HOTAZEL SOLAR PARK NEAR HOTAZEL,
NORTHERN CAPE PROVINCE (DEA REF. NO
14/12/16/3/3/2/987/AM1)

Draft EA Amendment Report
juwi Renewable Energies (Pty) Ltd

25 November 2019
Revision: 0
DEA Reference:
14/12/16/3/3/2/987/AM1

Figure 3-1 | Currently Authorised layout

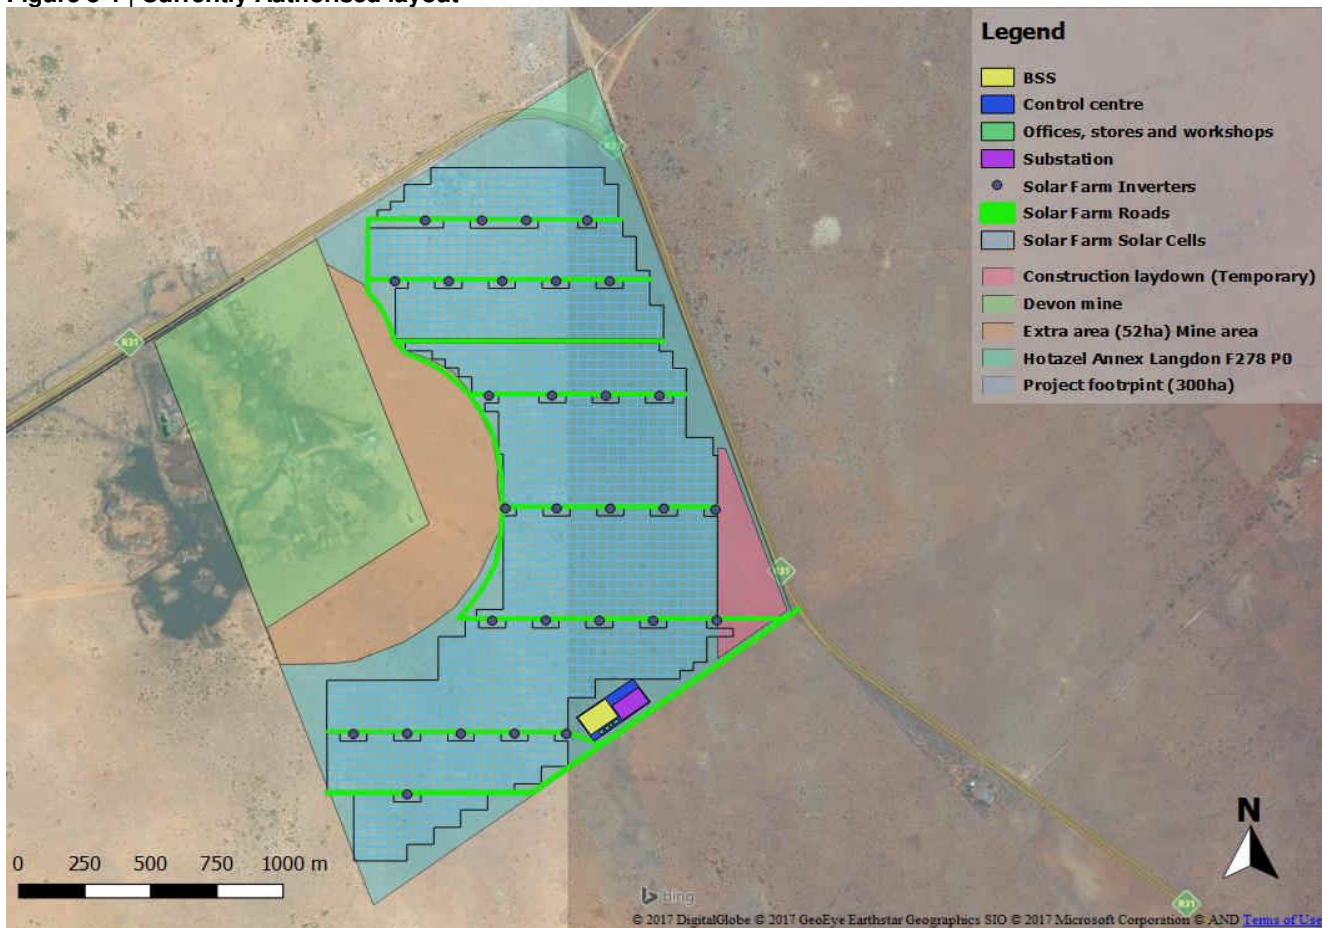
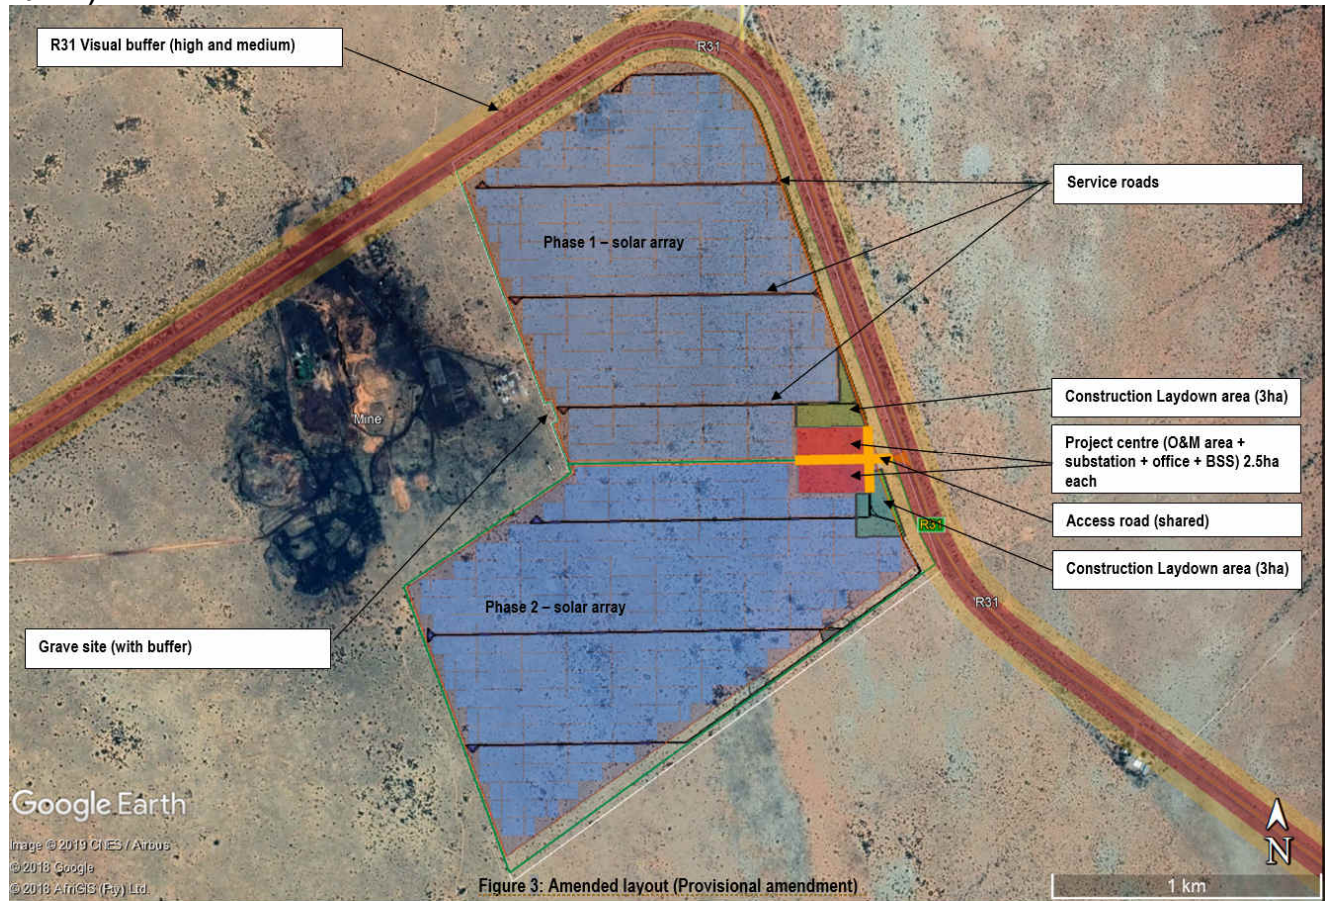
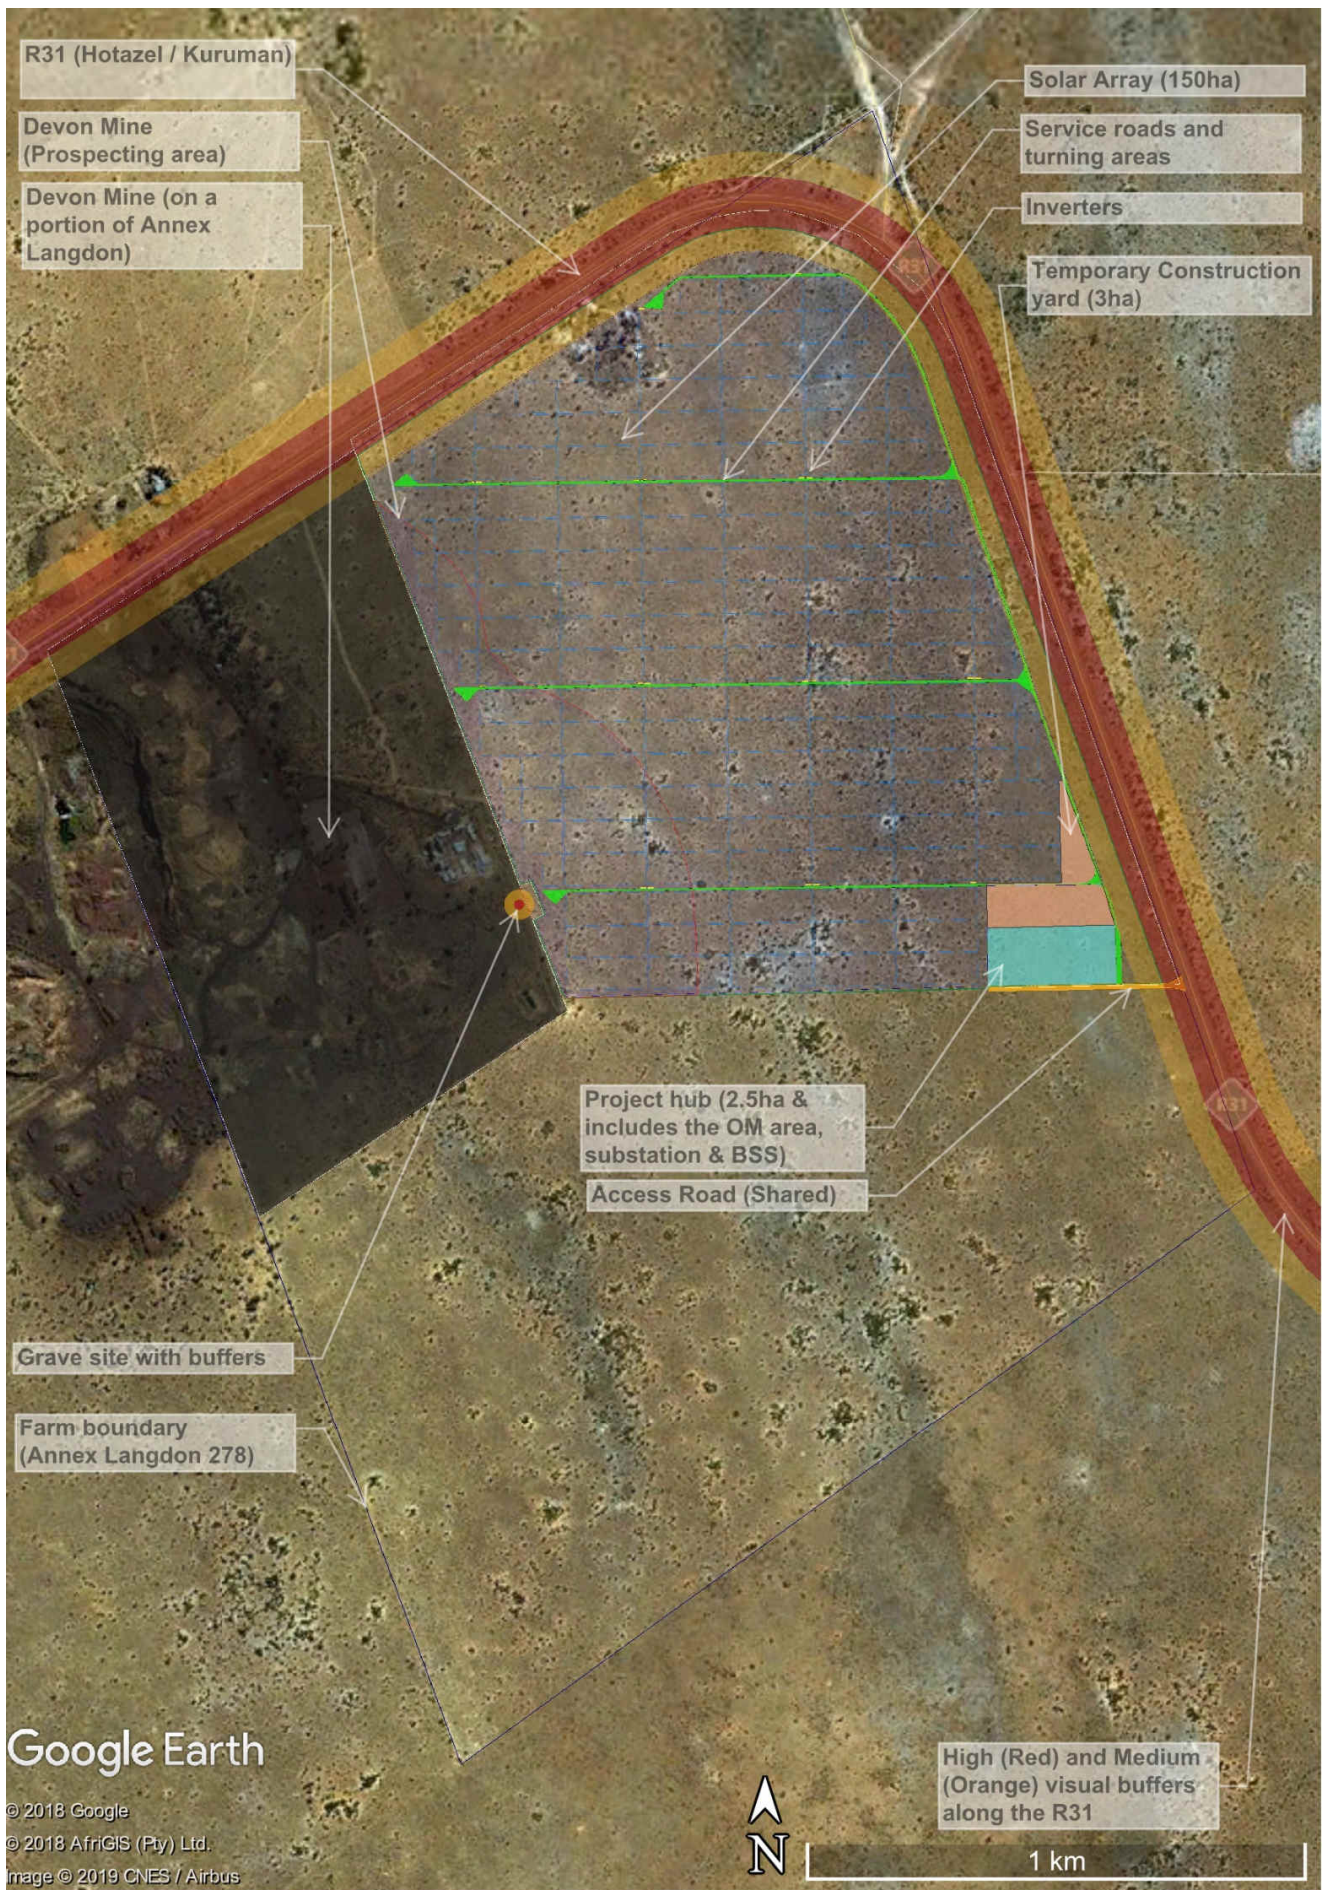
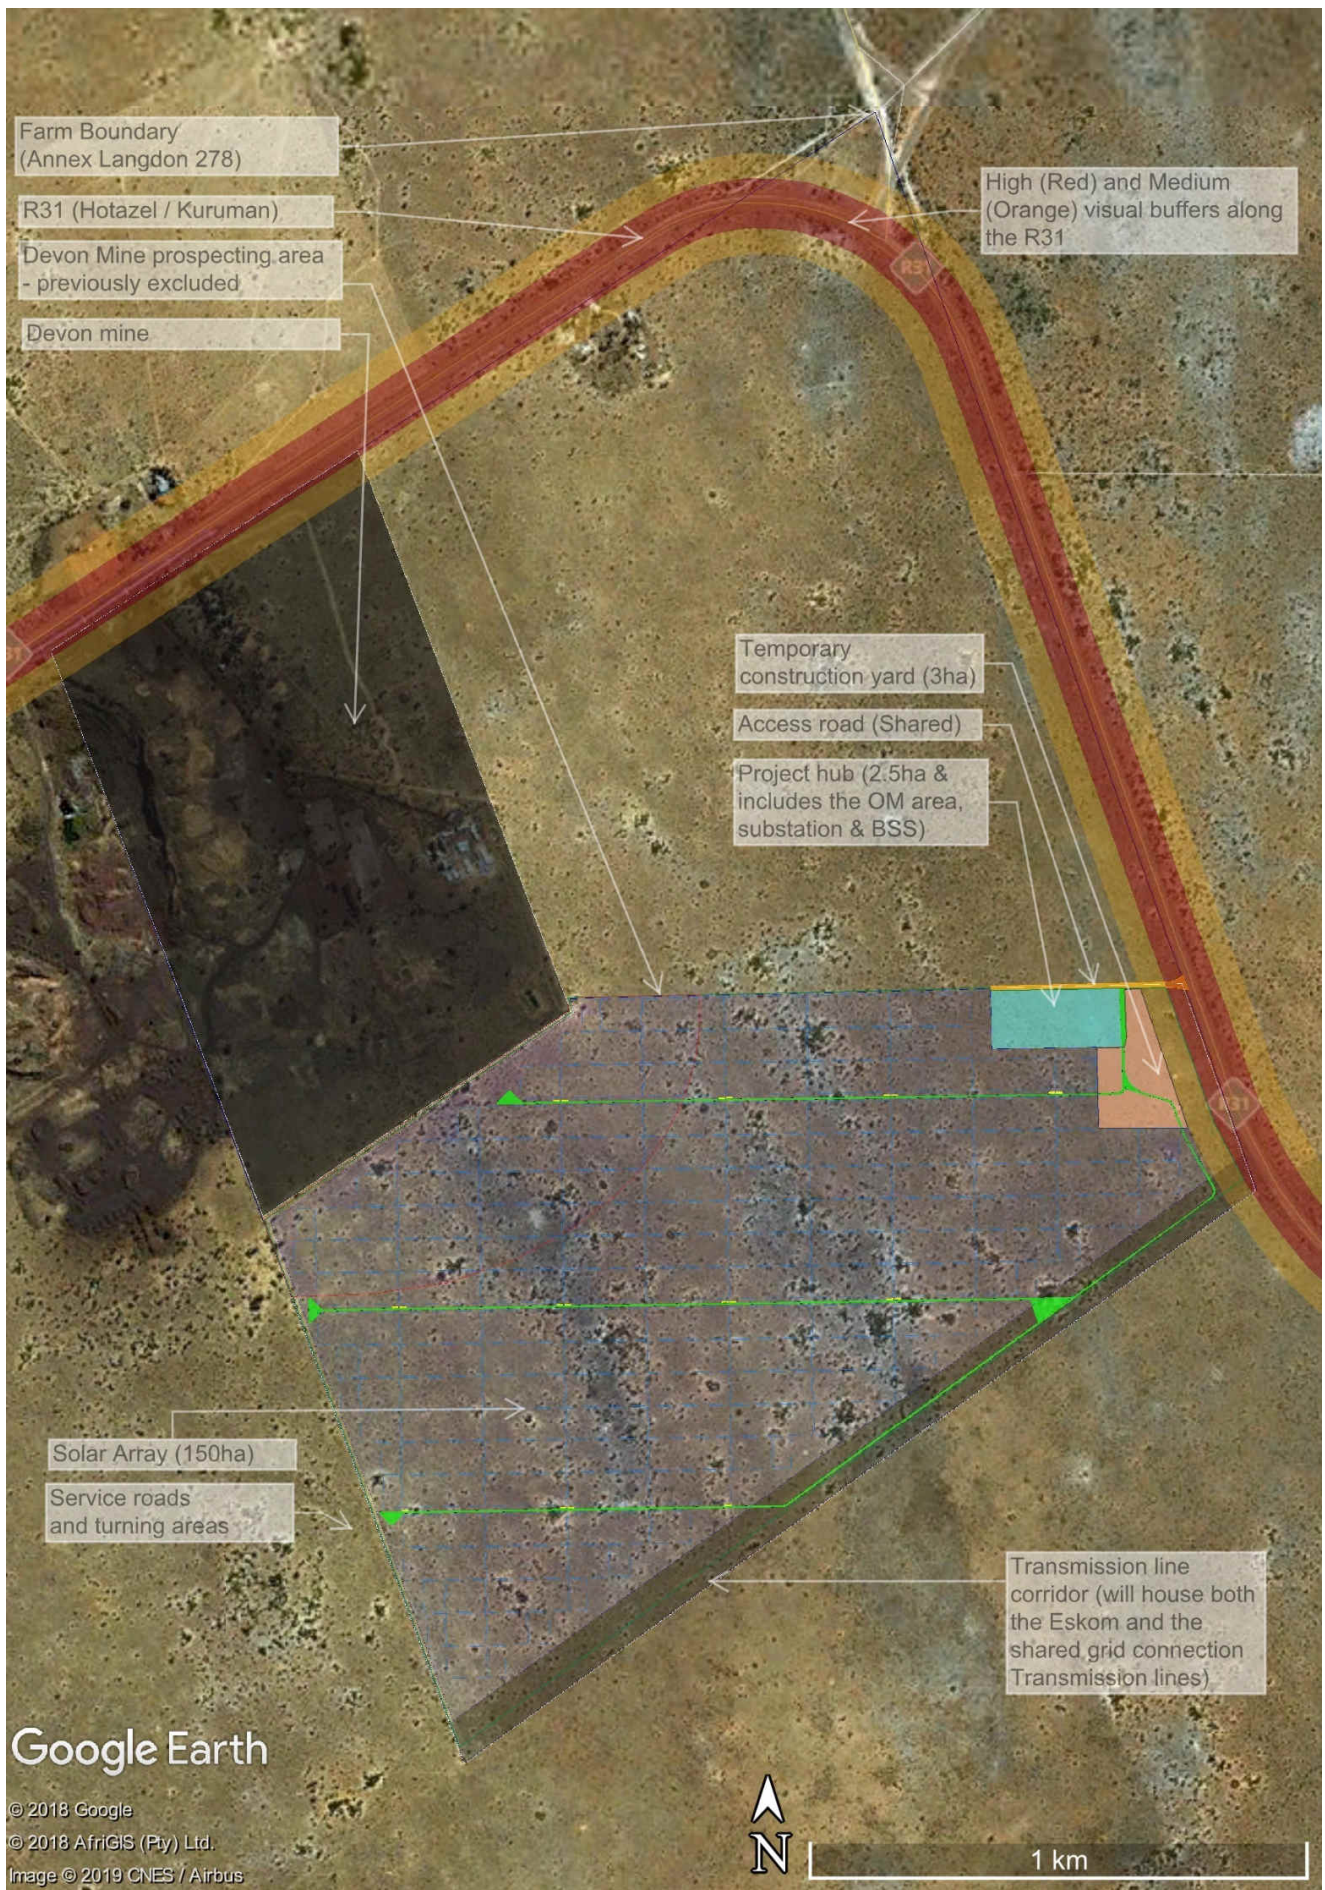
1. Expand the collective development area with 52ha (from 300ha to 352ha).
2. Split the project into two discreet 100MW solar facilities (1 Hotazel Solar Farm 1 and Hotazel Solar Farm 2), including the duplication and rearrangement support infrastructure and PV array (Revised layouts) as follows:

- a. One 250ha solar array (200MW) becomes two 150Ha 100MW solar arrays
 - b. One $\leq 100\text{MWh}$ battery storage facility (1ha) becomes two $\leq 100\text{MWh}$ battery storage facilities for energy storage facilities (2ha)

- c. A 1ha ($\leq 1.9\text{km}$ long, $\leq 8\text{m}$ wide) gravel access road becomes a shared 0.6ha (10m wide 600m long) gravel access road
 - d. 6.8ha of service road (17km, 4m wide) becomes 4.4ha of service road or two 2.2ha of service roads per project

- e. The one 1ha collector substation becomes two 1ha substations.
 - f. The one 4ha temporary laydown areas becomes two 3ha laydown areas
3. Update Applicant details for separate EAs (i.e. Hotazel Solar 1 (Pty) Ltd and Hotazel Solar 2 (Pty) Ltd).
